MEMO TO: City of Bayonne Planning Board

FROM: Malvika Apte, PP/AICP   
Consulting City Planner

RE: Bayonne Luxury Waterwalk, LLC  
Minor Subdivision  
Preliminary and Final Major Site  
Plan Planning Report # 2  
Block 300.01 Lots 1 and 6  
219 W 5<sup>th</sup> Street  
Bayonne, New Jersey  
Our File: PBYP0301.05  
Application # P-21-020

Site Plan  
 Source: CPA Architecture

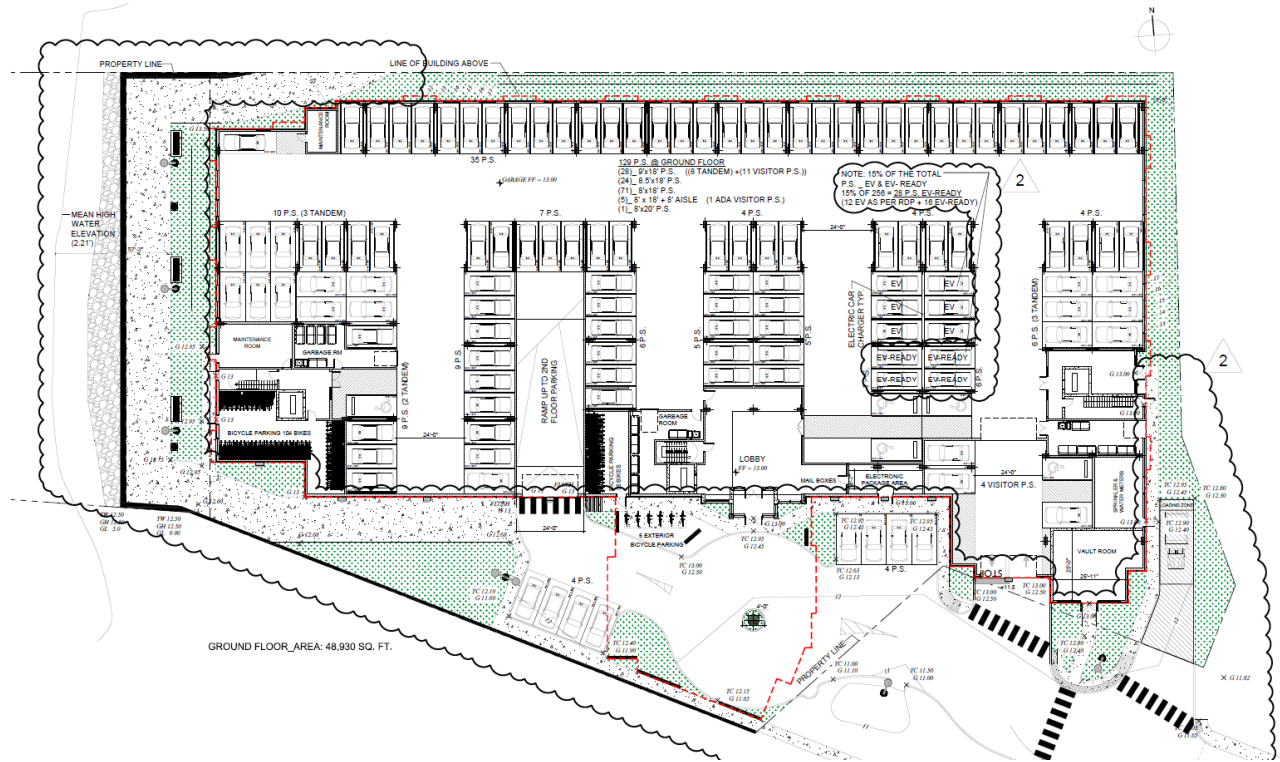
The applicant, Bayview Luxury Waterwalk, LLC is seeking a preliminary and final major site plan and minor subdivision to develop the aforementioned properties into a six (6) story with a mezzanine floor multi-family residential dwelling consisting of 180 residential units.

The property identified as Block 300.01 Lot 1 and 6 in the City tax records is located at the end of West 5<sup>th</sup> Street. The site has approximately 88 feet frontage on West 5<sup>th</sup> Street ( Lot 6) and approximately 100 feet ( Lot 1). The site has approximately 150 feet waterfront frontage.

With this proposal applicant is seeking to consolidate the two lots by deed and propose to develop the property with a six story residential building with two levels of parking comprising of 248 parking spaces and 180 units. The units comprise of fourteen (14) studio units, one hundred and eleven (111) one bedroom units and fifty five (55) two bedroom units. The residential units are located on third to sixth story including forty nine (49) duplex units.

Additional site improvements include a roundabout, along with eight (8) public parking spaces and a public walkway along the waterfront, connecting to the recently approved Bayview Development.
